Midway City Council
17 August 2021
Work Meeting

The Village Development /
Updated Plan

Date: August 17, 2021
To: Midway City Council
From: Michael Henke
Re: The Village – Revised Concept Plan

Exhibit 3 – Proposed Revised Rezone Concept Plan (August 17)

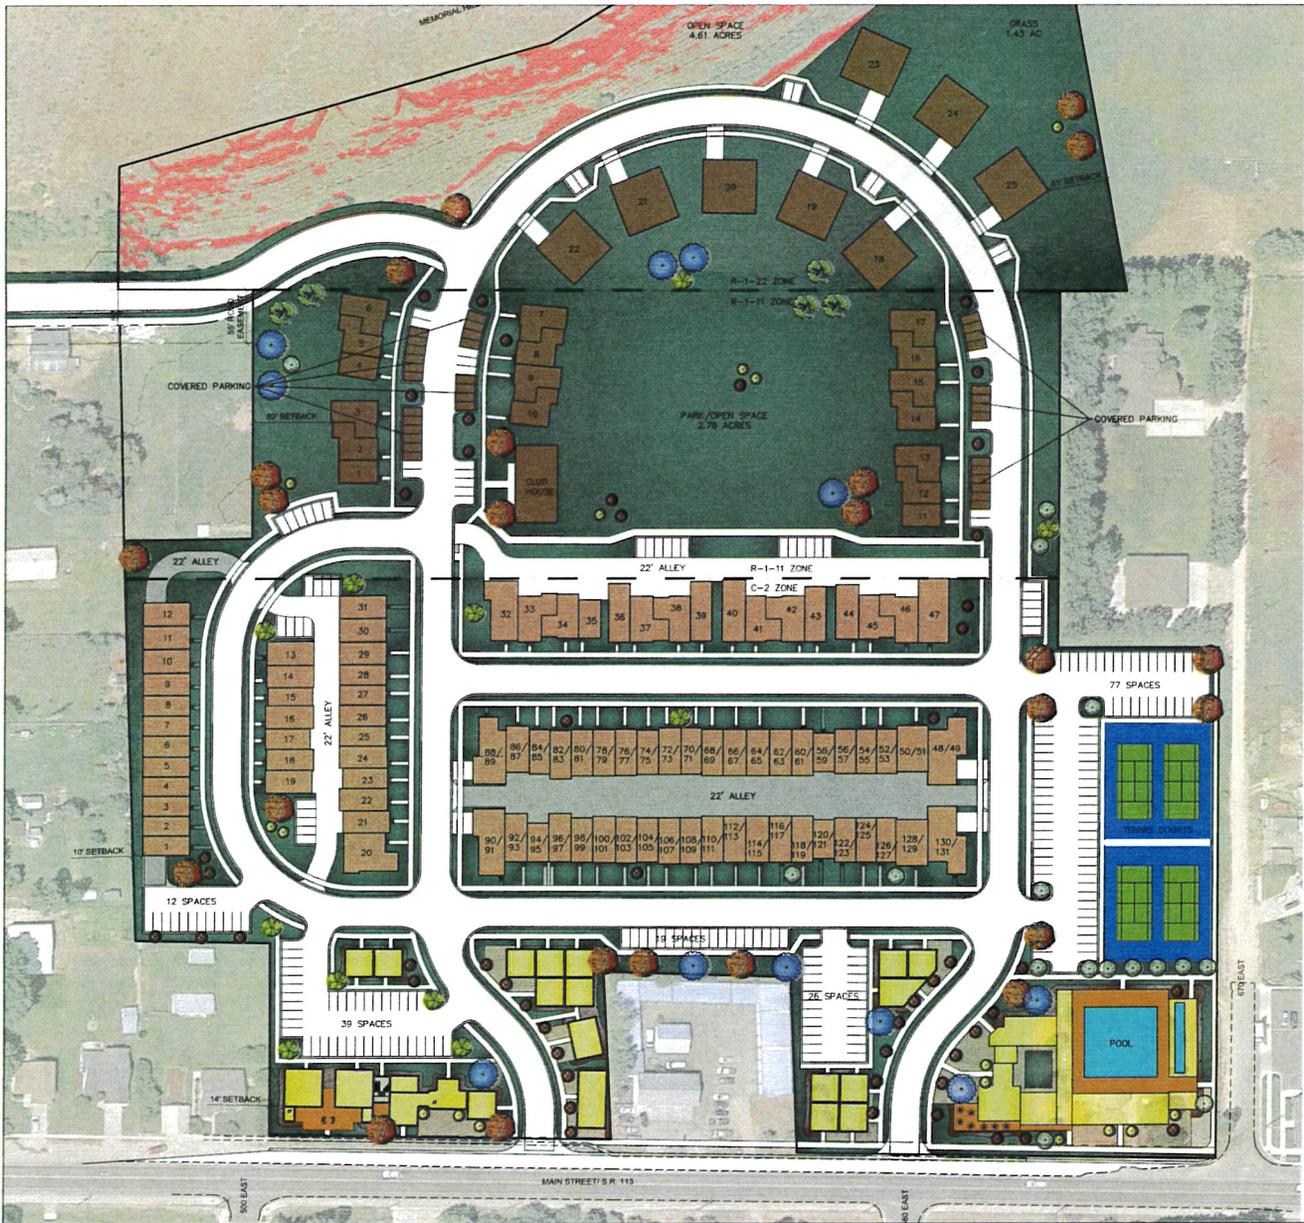
Dan Luster of Midway Heritage Development LLC, developer of The Village mixed-use project at 541 East Main Street, has submitted an updated concept plan (please see attached plan, Exhibit 3). The applicant has applied to rezone 13.34 acres of the project area from R-1-11 and R-1-22 zones to C-2. The proposed rezone would allow the mixed-use zoning code, which is an option in the C-2 zone, to be applied to the entire property which encompasses 27.47 acres. This would allow for more flexibility regarding density dispersion when designing the development with the goal of creating the best neighborhood possible based on the vision described in the General Plan.

The City Council last reviewed the proposal on July 6, 2021. In that meeting, after a public hearing, the City Council discussed the proposal, and several ideas were shared regarding adjustments to the plan that could be made. The developer has submitted a new plan based on comments made at the meeting. The following are some of the changes that have been made to the revised concept plan:

- Setbacks have been increased in the proposed rezone area to approximately 100'
- Setbacks in the area currently zoned C-2 have increased in some areas, notably along the western boundary where they were increased from 10' to 36' minimum except for the commercial building fronting Main Street.
- Three more units have been added near the eastern boundary of the project. The approved concept plan's density is 156 units. The first concept plan had 140 units. The newly revised concept plan has 143 units.

- An open area (0.24 acres) has been created on Main Street and a commercial building area has been reduced to create the open area.
- A 1,300 square foot commercial building footprint has been added.
- Some of the commercial building footprint areas have been moved.
- Parking stalls along the eastern boundary have been removed.
- Commercial parking stalls have been added near the commercial buildings.
- The tennis courts have been removed and replaced with a parking area.
- The approved concept plan had 10.33 acres of open space (areas at least 100' in width between structures or 60' between structures and boundary lines). The newly revised concept plan has 8.32 acres of open space.
- The building footprint areas for commercial and residential have been updated.
